**MERCERSBURG ACADEMY**  
**HEALTH CENTER PRE-BID CLARIFICATIONS**

**August 22, 2017**

**RESPONSE ISSUED 8/28/17**

**REFLECTED CEILING PLAN & ROOF PLAN**

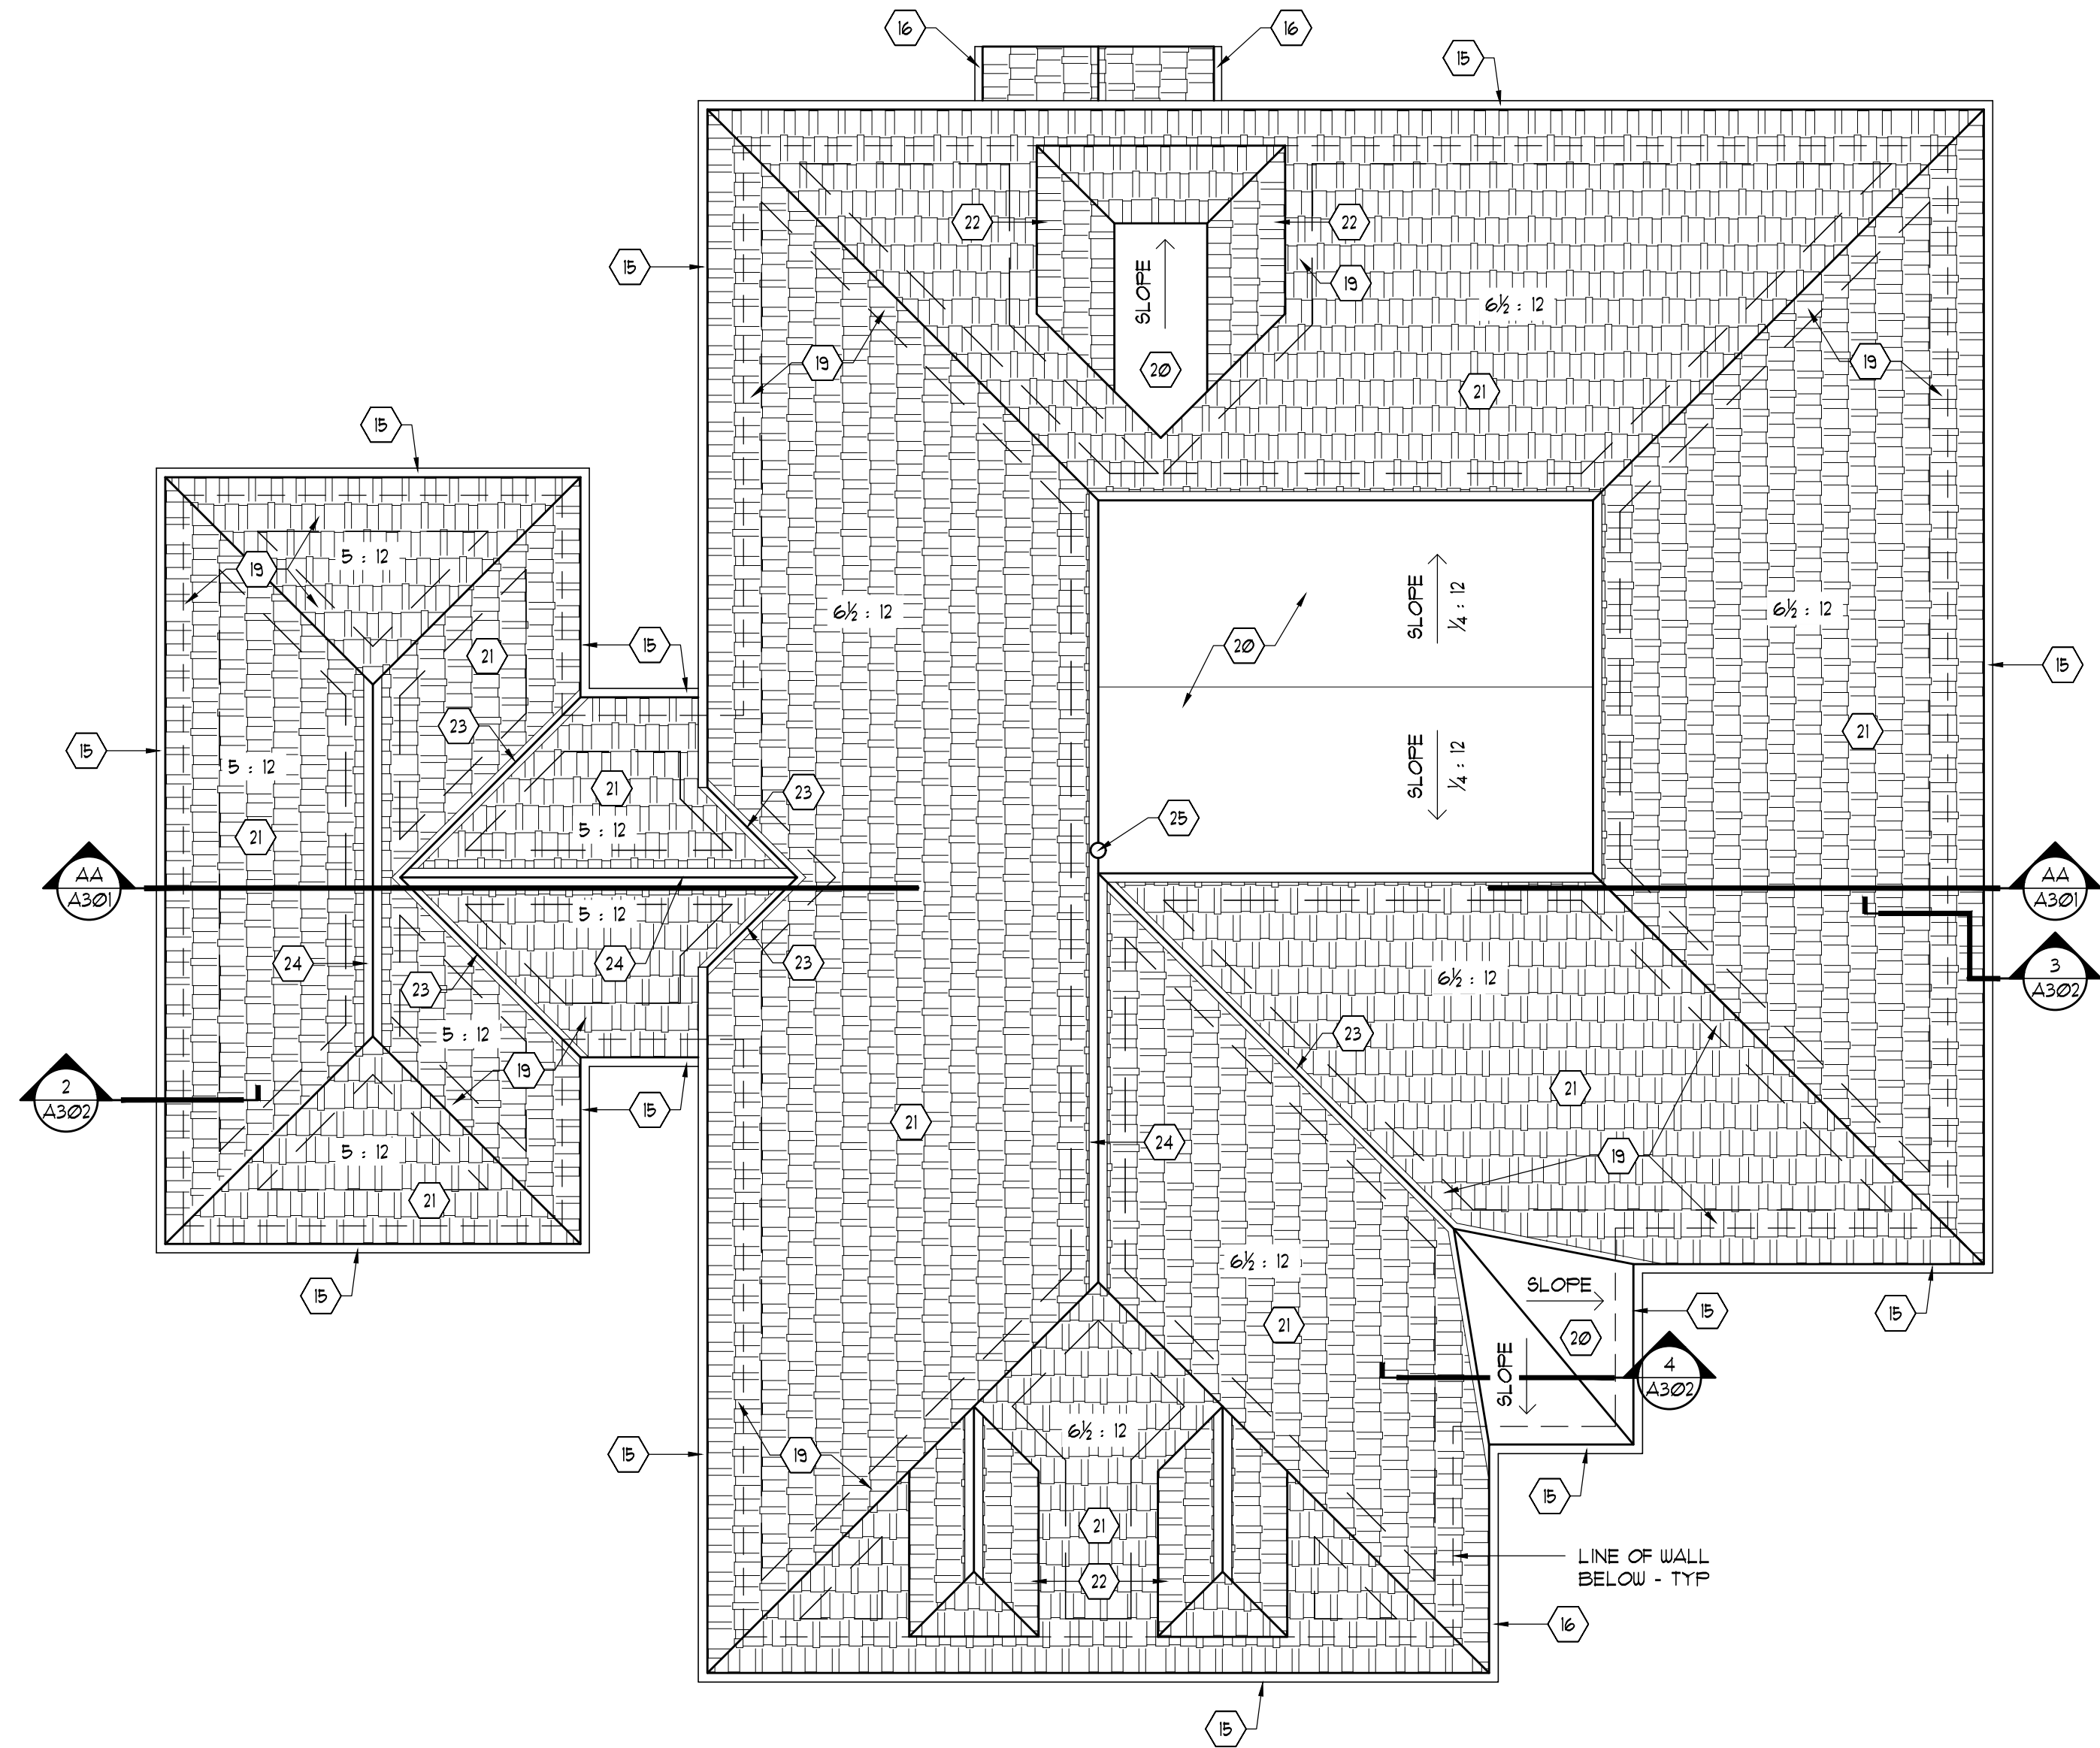
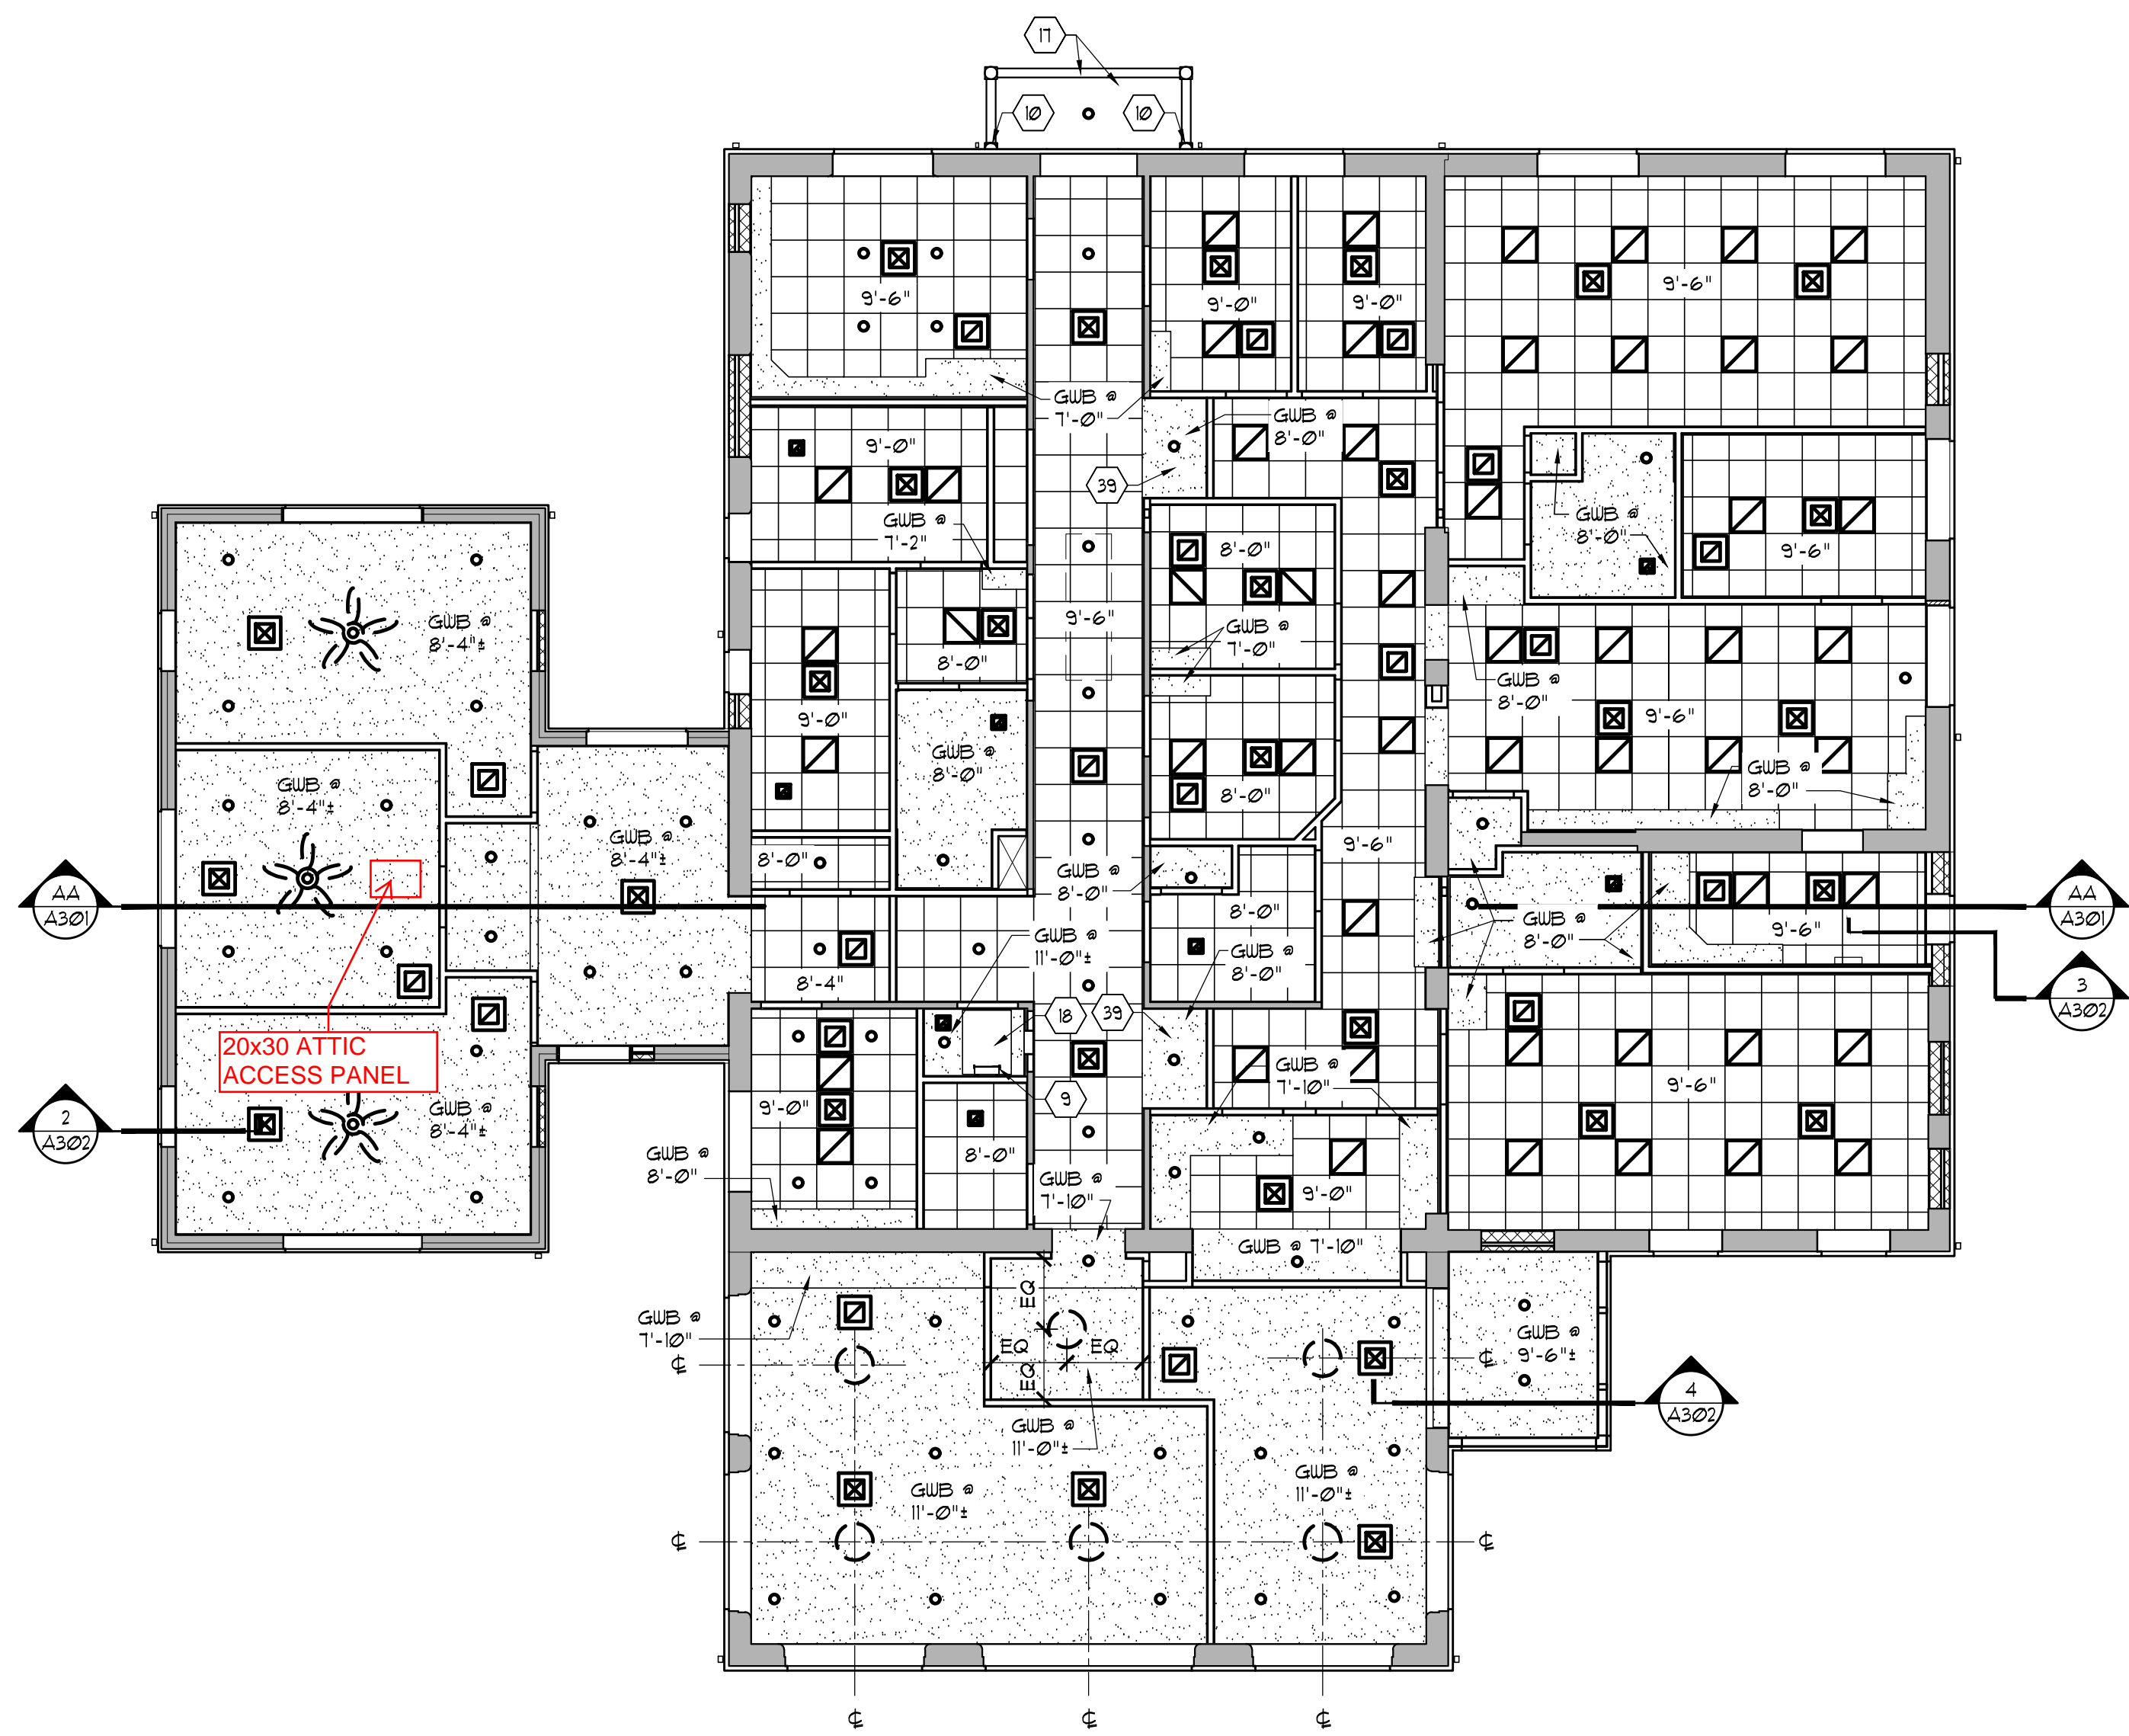
7. Please see the two attached drawings which request for direction in regards to a plan to access to these two locations, we reviewed the existing conditions in the field and it has been deemed that these areas are inaccessible due to obstructions or limited space to fit an actual person.

**Ref RFI drawing M102 (Attic Floor Plan): Ceiling to be removed during construction to allow work in space above. Head off roof framing and provide access hatch similar to access hatch in Janitor 104 to allow inspection/maintenance work in attic space. See attached 170830 - A102 and 170830 - A301 for additional information.**
